# Access Compliance Report

## Public Rights-of-Way

### (Curb Ramps)

Intersection ID: 1003387	Main Street: ROYAL_BLUFF_DR	Cross Street: N/A	Location: NE
ADA ID: 478DE76A2FD5	Ramp Type: Perp	Initial Pass/Fail: Fail	Overall Compliance: No
Severity Score: 21.25			
Codes/Mitigation Info/Possible Solution		Field Measurements/Component Compliance

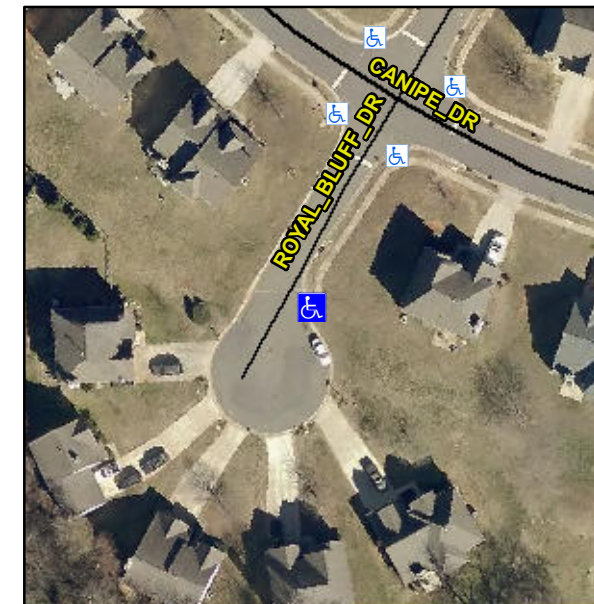
**Not Found, R304.5.1, R304.5.3**

Compliance	Description	Data	Compliance	Description	Data
N/A	Ramp Length (in)	49.5	Yes	Ramp Slope (%)	7.6
No	Ramp Width (in)	47.2	No	Ramp XSlope (%)	5.4
N/A	Flare Type LT	N/A	N/A	Flare Type RT	N/A
N/A	Flare Slope LT (%)	N/A	N/A	Flare Slope RT (%)	N/A
N/A	Flare Traversable LT?	N/A	N/A	Flare Traversable RT?	N/A
N/A	Landing Length (in)	N/A	N/A	DWS Provided?	N/A
N/A	Landing Width (in)	N/A	N/A	DWS Contrast?	N/A
N/A	Landing Slope (%)	N/A	N/A	DWS Length (in)	N/A
N/A	Landing X Slope (%)	N/A	N/A	DWS Full Width?	N/A
N/A	Landing Curb? (Y/N)	N/A	N/A	DWS Offset (in)	N/A
N/A	Shared Landing?	N/A			
N/A	Gutter Ponding?	N/A	N/A	Gutter Slope (%)	N/A
N/A	Gutter Lip Ht (in)	N/A	N/A	Gutter X Slope (%)	N/A
N/A	Painted X Walk1?	No	N/A	Painted X Walk2?	N/A
	X Walk 1 Direction	To SW		X Walk 2 Direction	N/A
N/A	X Walk 1 Width (in)	N/A	N/A	X Walk 2 Width (in)	N/A
	X Walk 1 Slope (%)	4.6		X Walk 2 Slope (%)	N/A
	X Walk 1 X Slope (%)	0.2		X Walk 2 X Slope (%)	N/A

**Remove & Replace Entire Ramp.**
